Project No. 2628-066

R.L. Harris Hydroelectric Project

Response to August 29, 2022 Harris Project License Application Additional Information Request - Schedule A

**Figure 1 Conceptual Design of Proposed Minimum Flow Unit with High Level Intake**

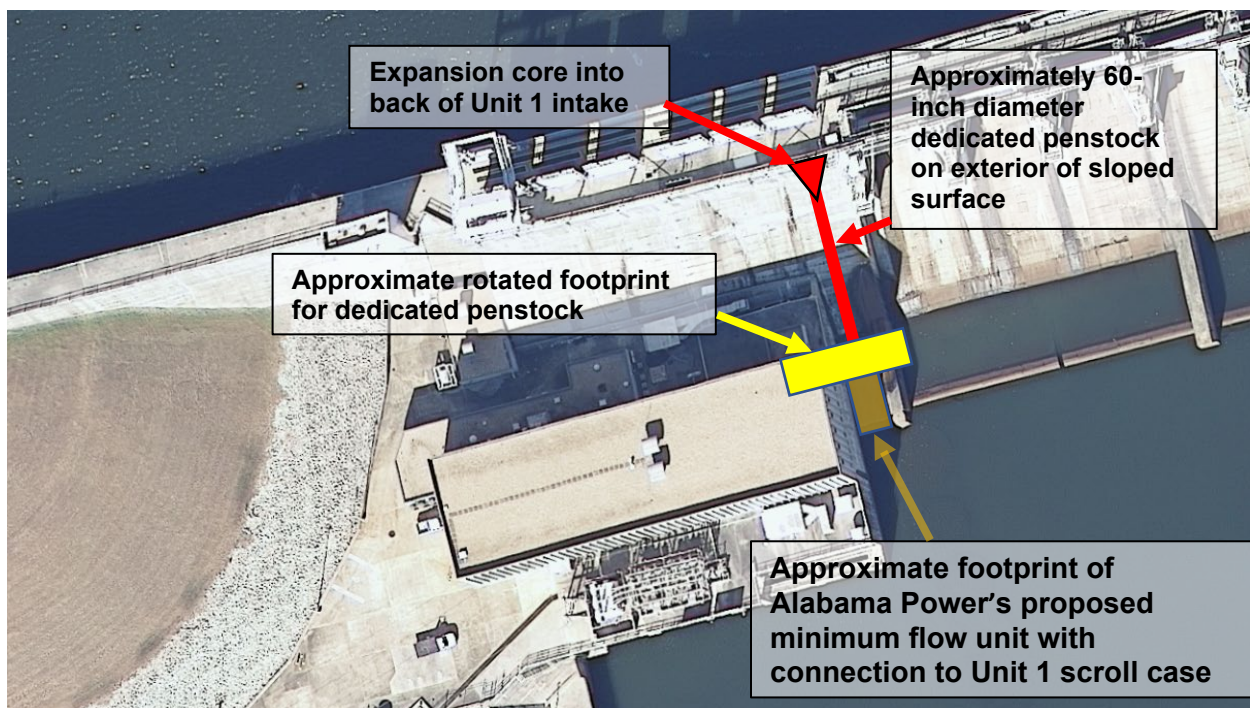
- a) *for each mechanism (i.e., a modified minimum flow turbine-unit, siphon-system, pump-system, and modified-gate release), a description of structural modifications to the dam or other project facilities to accommodate a high-level intake, the feasibility (time, cost, effectiveness, etc.) of the modifications, and any specific safety concerns associated with such modifications;*

- b) *a conceptual plan for a minimum flow turbine system utilizing a high-level intake to pass up to 300 cfs, including: (1) the location, number, size, and type of turbine(s) that would be used; (2) an estimate of the annual generation (in kilowatt-hours) and the hydraulic capacity of each turbine unit (in cfs), if different from the license application proposal (300 cfs); (3) the location and description (composition, dimensions, configuration, etc.) of the intake and discharge conveyance structures; (4) the elevation necessary for an intake structure to operate during winter pool surface water elevation of Harris Lake; (5) a description of the estimated installation costs, with itemized costs for the flow release mechanism and associated project modifications; and (6) an estimate of operation and maintenance (O&M) costs, including energy gains/losses (due to differences in head);*

An evaluation of installing a high-level, dedicated intake from the forebay to the proposed minimum flow system was conducted using existing information and drawings from Harris Dam. Existing Units 1 and 2 are supplied with water from a round penstock. At the headworks, the round penstock is trifurcated into three large rectangular openings relatively close to the reservoir surface. The total opening for each unit at the intake level is approximately 2500 square feet. The large openings are required because of low hydrostatic pressure near the surface and the need to supply each unit with flows necessary for all operations. In order to supply the minimum flow unit with a water flow of approximately 300 cfs, an opening of approximately 120 square feet (or, if round, a pipe diameter of approximately 12 feet) would be required at the intake level. This is a very conservative estimate considering the invert of the minimum flow intake would be higher than the invert for the existing units. The easternmost trifurcation intake channel for Unit 1 is located directly above the non-overflow section where the minimum flow unit would be located. A large opening (i.e., 120 square feet or, if round, approximately 12 feet in diameter) cored into a 51-degree slope approximately 60 feet above the powerhouse is a major concern in terms of structural integrity and safety, not to mention the difficulty to core on this slope at a high distance above level grade. In fact, the steep concrete slope of the dam may require that access and coring be performed from the intake side of the penstock. In either case, additional concrete work would need to be performed on the reservoir side of the intake, requiring the stop logs to be removed for access. For this work to occur, the reservoir would need to be held at an elevation below 746.0 feet mean sea level (ft msl; the bottom of the unit intake), which is 39 feet below winter pool, for an extended period during construction. Holding the elevation at 746.0 ft msl or below would create a risky scenario during even a normal rainfall event because both units and the spillway would be unavailable to pass water. The unavailability stems from the fact that the spillway crest is at elevation 753.0 ft msl, or seven feet above bottom of the unit intake, and the mechanical operating limit of Unit 2 is elevation 768.0 ft msl. With no way to evacuate water, construction equipment and the stage of construction could prevent insertion of headgates or stoplogs to block rising water in Unit 1. This could be very serious if the bore or cut to the back slope of the dam for the new minimum flow penstock was open. Further, Alabama Power has a responsibility

under the U.S. Army Corps of Engineers (USACE) and FERC regulations to operate the Harris project for flood control consistent with the rules and regulations prescribed by the USACE. Without the ability to operate the Harris project consistent with procedures established in those rules and regulations, Alabama Power would be violating its responsibilities and needlessly risking danger from flood damage to life, health and property, both upstream and downstream of Harris dam. As such, Alabama Power would not operate Harris in this manner, and would not approach the USACE asking for permission to do so.

Additionally, the minimum flow unit design, as proposed, receives water through the Unit 1 penstock that is parallel to the axis of the dam. The approximate footprint of the proposed minimum flow unit with connection to the scroll case is shown as a faded yellow rectangle on Figure 1. As depicted in Figure 1, to create a separate intake for the minimum flow unit, the penstock (shown in red on Figure 1) would have to be routed perpendicular to the axis of the dam. Therefore, the entire generator and turbine layout for the minimum flow unit would have to be rotated 90 degrees, shown in Figure 1 as a bold yellow rectangle. A 300 cfs unit requires no less than 40 feet of width; however, the proposed powerhouse extension for the minimum flow unit is limited to approximately 25 feet wide wall to wall on the inside. The change in orientation required to construct a separate intake for the minimum flow unit would result in a significantly smaller minimum flow unit and therefore, a significantly smaller continuous minimum flow release<sup>1</sup>.

Because of serious structural integrity and safety concerns with coring through the dam, extreme impacts to lake levels and flood control procedures during construction, significant reduction in the amount of flow the unit would be able to release, and importantly, passing water from a higher intake elevation would result in an increase in the average and maximum daily and hourly temperature deltas downstream of Harris dam (see response to Question 2), creating a separate minimum flow unit intake is neither feasible nor reasonable, and therefore an option that Alabama Power will not pursue.

**Figure 2 Conceptual Design of Siphon System**

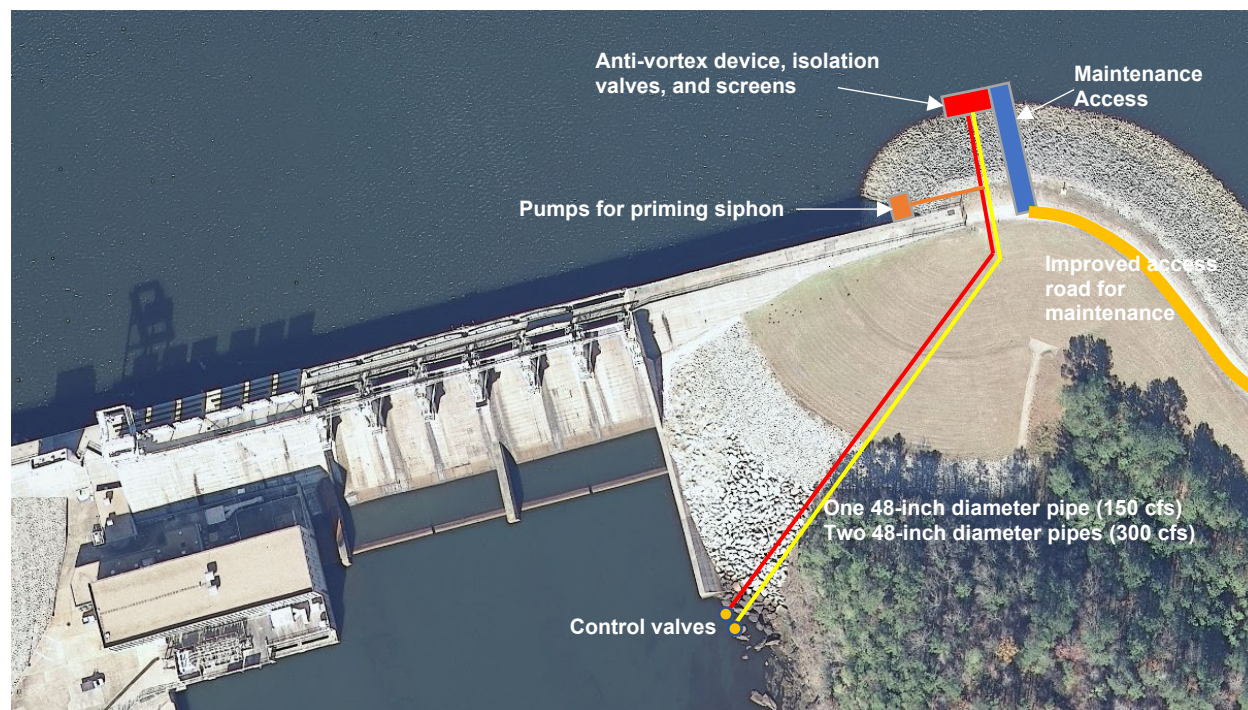
- c) *a conceptual plan for a siphon-system utilizing a high-level intake that could pass up to 300 cfs. In Alabama Power's response to staff's February 15, 2022 AIR Item #2, use of a siphon was the only mechanism evaluated for providing minimum flows that would draw from the epilimnion. Alabama Power states that this strategy was determined to be physically feasible on the east side of the dam in 2003, but required an estimated cost of \$10,000,000 for installation and \$75,000 for annual O&M. Alabama Power provided few details on the potential design for a siphon system, and has not evaluated the feasibility and cost if a siphon system was deployed to provide minimum flows only during the summer months when Harris Lake is at full pool elevation. The plan should include: (1) a detailed description of the syphon system including the size, depth, and location of the intake and piping; (2) an itemized list of estimated costs for installation of the mechanism and any modifications to existing project features; and (3) estimated O&M costs, including energy loss from the minimum flow release, between continuous operation of the system versus operation solely when Harris Lake is at full pool;*

If a siphon were to be installed at Harris Dam, it would necessarily be located on the east side of the spillway, as depicted in Figure 2 below. To ensure the road across Harris Dam continues to be usable, a notch would have to be cut into the east embankment or east non-overflow section of the dam. Capital costs for installation are estimated to be \$10M for one 150 cfs siphon and \$20M for two 150 cfs siphons (to provide 300 cfs) and would be the same whether the system operated year-round or only at full pool.

A review of available information shows that widespread use of siphons as a reliable, permanent, continuous flow device is almost non-existent at hydropower projects for even small flows. Poor reliability is most likely the main reason because of the many factors that can cause the siphon to cease operation, which in turn creates a new set of challenges for O&M and maintaining continuous flow. These challenges were described in detail in Alabama Power's response to the February 15, 2022 AIR.

To determine the energy gains and losses for passing 300 cfs through a siphon-system, Alabama Power utilized the same HydroBudget model developed for the downstream release alternatives presented in the Downstream Release Alternatives Phase 2 Report (Alabama Power and Kleinschmidt 2022). The HydroBudget model indicates that releasing 300 cfs through a siphon-system continuously (i.e., year round) would result in an annual energy loss of 24,826 megawatt hours (MWHrs) and an annual revenue loss of \$704,168 at Harris Dam compared to the Green Plan (baseline). The HydroBudget model indicates that releasing 300 cfs through a siphon-system only when Lake Harris is at full pool (May 1 through September 30) would result in an annual energy loss of 10,717 MWHrs and an annual revenue loss of \$289,893 at Harris Dam compared to the Green Plan (baseline).

The use of a siphon system at Harris Dam is not a reasonable alternative due to high capital costs, potential dam safety concerns<sup>2</sup>, maintenance and reliability issues that would result in interrupted minimum flow, and significant impacts to generation and revenue from flow being passed by a non-generation mechanism. Also, passing water from a higher intake elevation would result in an increase in the average and maximum daily and hourly temperature deltas (see response to Question 2).

**Figure 3 Conceptual Design of Pump System**

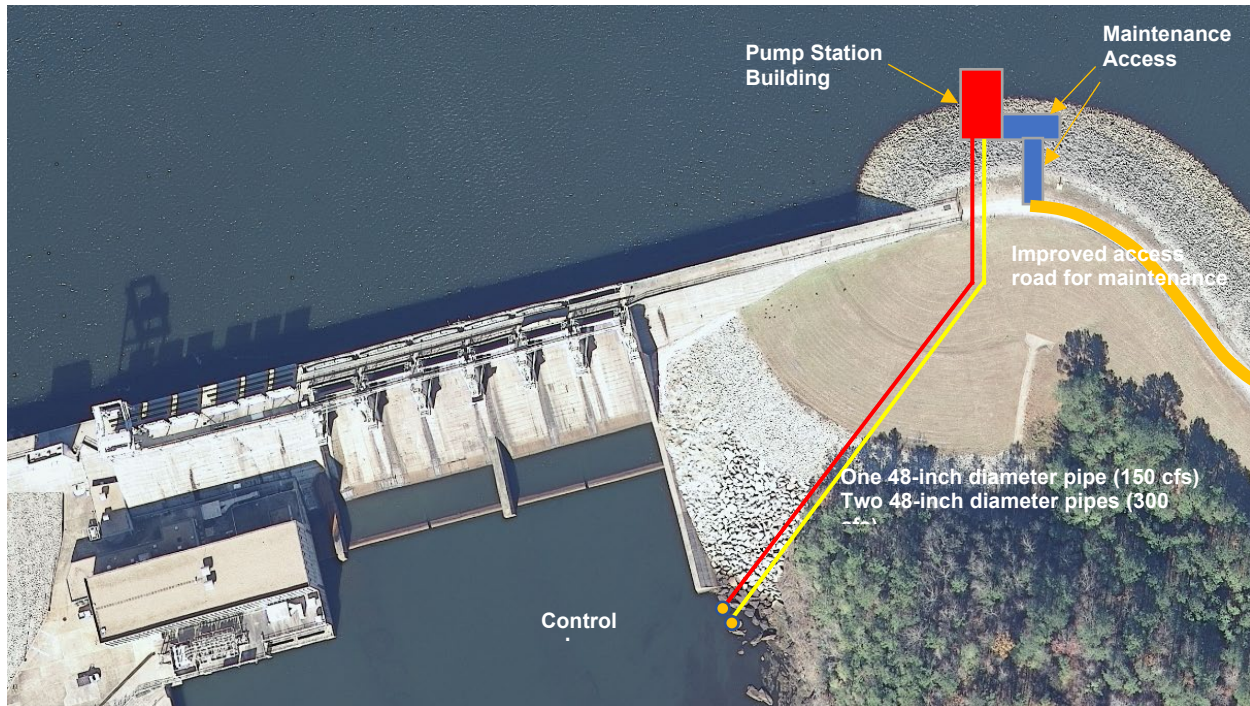
- d) *a conceptual plan for a pump-system utilizing a high-level intake to pass 150 cfs and 300 cfs. The plan should include: (1) a detailed description of the pump-system including the size, depth, and location of the intake and piping; (2) an itemized list of estimated costs for installation of the mechanism and any modifications to existing project features; and (3) estimated O&M costs, including energy losses to operate the pumps, energy losses to pass the minimum flow, and any cost savings from operating the pumps only at full pool versus one that would be operated continuously; and*

In order to use a pump-system to provide a continuous minimum flow downstream of Harris Dam, a large concrete pump station would need to be constructed at the edge of the reservoir on the east embankment. Two things would need to be considered in designing the pump(s) in order to avoid cavitation in the system and therefore avoid damage to the pump and to the piping system downstream of the pump location. The first consideration is the discharge head of the pump. Using data from MWI Pumps, Inc., the pump type required for this use is a mixed-flow design.<sup>3</sup> A 48-inch pump is the minimum size that will deliver a 150 cfs (67,300 GPM) flow required at a total dynamic head (TDH) of between 40 and 45 feet. This TDH is required to prevent cavitation in the piping downstream of the pump. If cavitation were to occur in the piping system downstream of the pump, vapor would rise to the high point of pipe system and form a bubble that would effectively reduce the pipe diameter, causing excessive back pressure on the pump. This would lead to premature failure of the pump motor. The second consideration is the position of the pump centerline relative to the reservoir elevation. The pump would need to be positioned low enough so that the net positive suction head available is greater than the net positive suction head required by this specific manufacturer's pump. If this requirement is not met, cavitation will occur inside the pump and the pump will prematurely fail.

The intake diameter of a 48-inch mixed-flow pump is 64 inches with an impeller diameter of 42.3 inches and a discharge diameter of 48 inches. A 48-inch diameter discharge pipe would be required in order for the velocity to be below 12 feet per second, which is common engineering design practice. Using the manufacturer's data, the motor size required would be approximately 1000 horsepower. For a continuous 150 cfs pumping scenario, the annual parasitic energy requirement would be approximately 6,600 MWhr.

The pump station would require three-phase power be routed from the main powerhouse switching yard to the new pumps on the east embankment. Monitoring and control wiring must be installed from the powerhouse control room to the pump building. Site access for construction vehicles and maintenance trucks carrying the pumps and/or motors would not be available on the existing road from across the dam. The approximate one-mile road on top of the east embankment would need to be improved to the east to the paved county road. The pump building would house pumps, a crane system for maintenance, motor starters, breakers, and other ancillary equipment. The external piping system would require a motorized isolation valve, anti-vortex device, and screens on the intake side. The discharge end at the tailrace would require a motorized control valve.

Redundancy and configuration must also be considered since repairs to pumps and motors usually have a long lead time. A redundant system for the 150 CFS flow would require an additional pump of the same type/size in a parallel setup with isolation valves connected to the common intake and discharge pipe. A 300 cfs system with no redundancy would require two pumps and two pipelines (and would have an annual parasitic energy requirement of approximately 13,200 MWhr). A fully redundant 300 cfs system would require four pumps, two pumps in parallel on each of the two piping systems.

Because the use of pumps for a minimum flow would require a major infrastructure addition, Alabama Power anticipates the cost would be on par with the installation of the proposed minimum flow turbine (i.e., tens of millions of dollars). However, in addition to the significant impact to generation and revenue from water being passed by a non-generation mechanism, the pumps would require an extreme amount of energy to operate. For these reasons, and because passing water from a higher intake elevation would also result in an increase in the average and maximum daily and hourly temperature deltas (see response to Question 2), the use of pumps to provide a continuous minimum flow is not a reasonable alternative.

**Figure 4 Schematic of Theoretical High-Level Intake Location**

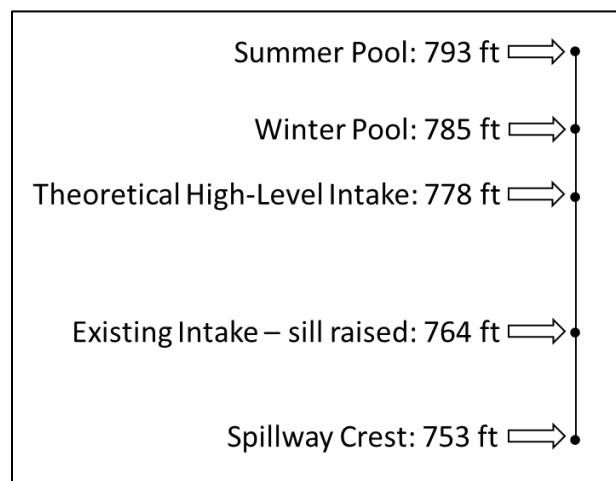
2. Alabama Power developed Environmental Fluid Dynamics Code (EFDC) and Hydrologic Engineering Center's River Analysis System (HEC-RAS) models during the prefilng phase of the relicensing process to provide quantitative estimates of the potential environmental benefits from the proposed downstream release alternative (i.e., the proposed minimum flow turbine-unit with a low-level intake) to water temperatures and DO concentrations in the Tallapoosa River downstream from Harris Dam. In order to help us understand the potential environmental benefits of using a high-level intake to improve water quality downstream from Harris Dam, please use the EFDC and HEC-RAS models to evaluate the effects of each of the scenarios in Table 1 below. Please include the effects on water temperature and DO at points in the immediate tailrace area, and 7 miles downstream from the project. In addition, please update exhibits throughout the license application to reflect these scenarios.

1. **450SURF**: A year-round, continuous release of 450 cfs from the surface of Lake Harris. This simulates a release of the warmest, most oxygenated water possible.
2. **450\_778**: A year-round, continuous release of 450 cfs from a theoretical high-level intake located at 778 ft msl (see Figure 4).
3. **300\_778**: A year-round, continuous release of 300 cfs from a theoretical high-level intake located at 778 ft msl.

The 450SURF scenario was chosen based on the assumption that FERC is exploring ways to increase downstream water temperatures. A surface minimum flow release represents the greatest potential for increasing downstream water temperatures; i.e., what the downstream temperature could be if the entire release could be as warm as what was recorded at the surface for each season. For the 450\_778 and 300\_778 scenarios, a theoretical high-level release elevation of 778 ft was chosen because (1) it is high enough that it could be utilized at both summer and winter pool levels, and (2) below this level, water in the forebay typically has lower water temperatures.
